Access Compliance Report Public Rights-of-Way (Curb Ramps)

Main Street: FAIRHAVEN_AVE Cross Street: OLYMPIA_WAY Location: NW

ADA ID: RPAT211022090147 Ramp Type: Type 4 - Parallel Initial Pass/Fail: Fail Overall Compliance: No Severity Score: 15

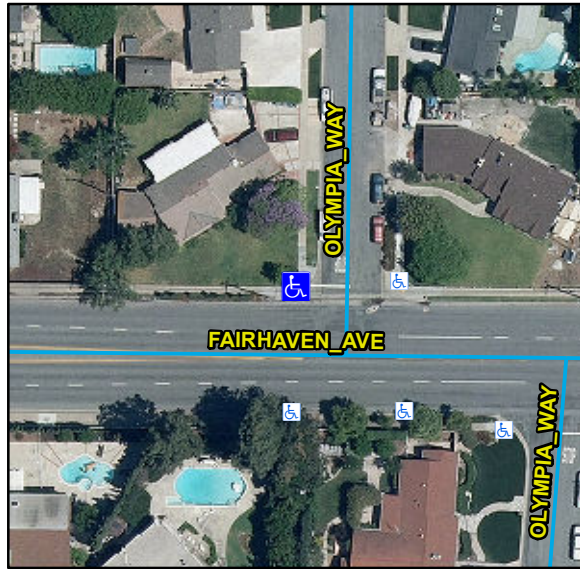
Compliance	Description	Data	Compliance	Description	Data
N/A	Ramp Length LT (in)	125	N/A	Ramp Length RT (in)	134
Yes	Ramp Width LT (in)	53	Yes	Ramp Width RT (in)	67
Yes	Ramp Run Slope LT (%)	6.5	Yes	Ramp Run Slope RT (%)	7.8
No	Ramp Cross Slope LT (%)	6.9	Yes	Ramp Cross Slope RT (%)	1.3
N/A	Landing Present	N/A	N/A	DWS Provided	N/A
N/A	Landing Length (in)	N/A	N/A	DWS Contrast	N/A
N/A	Landing Width (in)	N/A	N/A	DWS Length (in)	N/A
N/A	Landing Run Slope (%)	N/A	N/A	DWS Full Width	N/A
N/A	Landing Cross Slope (%)	N/A		DWS Offset Type	N/A
N/A	Landing Movement Obstructed?	N/A	N/A	DWS Offset Left (in)	N/A
	Landing Movement Type	N/A	N/A	DWS Offset Right (in)	N/A
N/A	Landing Shared	N/A			
N/A	Clear Space	Yes			
N/A	Clear Space To Crosswalk (in)	N/A			
N/A	Marked Crosswalk 1	No	N/A	Marked Crosswalk 2	No
	Crossing 1 Direction	S		Crossing 2 Direction	E
	Marked Crosswalk 1 Width (in)	N/A		Marked Crosswalk 2 Width (in)	N/A

Remove & Replace Curb Ramp With Two New Directional Ramps or Equivalent.

R304.5.3, STD 1115
